ALERT SERVICE BULLETIN

407-21-122

MODEL AFFECTED: 407

SUBJECT: MAIN ROTOR PITCH LINK TUBE ASSEMBLY
406-010-413-119/-133/-139, INSPECTION AND
APPLICATION OF TORQUE SEAL LACQUER.

Figure 1 – Torque Seal Lacquer (C-049) Application

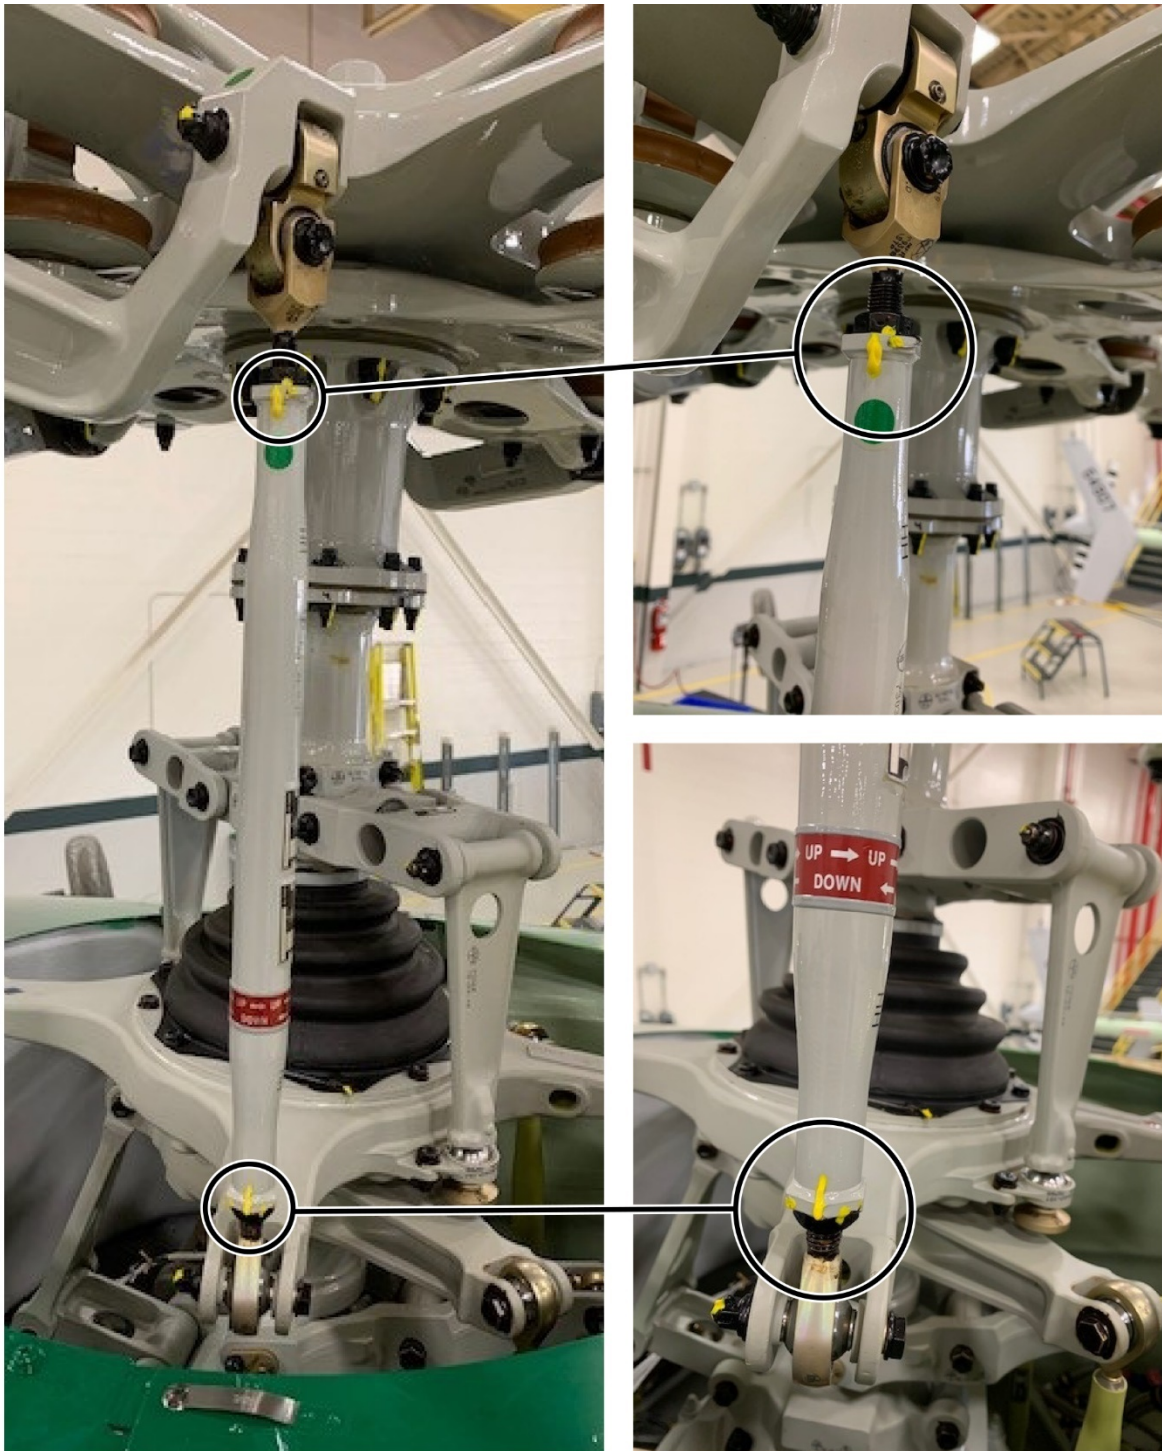
4. Apply torque seal lacquer (C-049), or equivalent, across the main rotor pitch link tube and the upper and lower inserts as shown (Figure 1).
5. Make an entry in the helicopter logbook and historical service records indicating compliance with **PART I** of this Alert Service Bulletin.

- (2) If the insert is not debonded, re-apply torque seal lacquer (C-049), or equivalent, as shown (Figure 1).
- (3) If the insert is found debonded, or suspected to be, go to step 2.c.
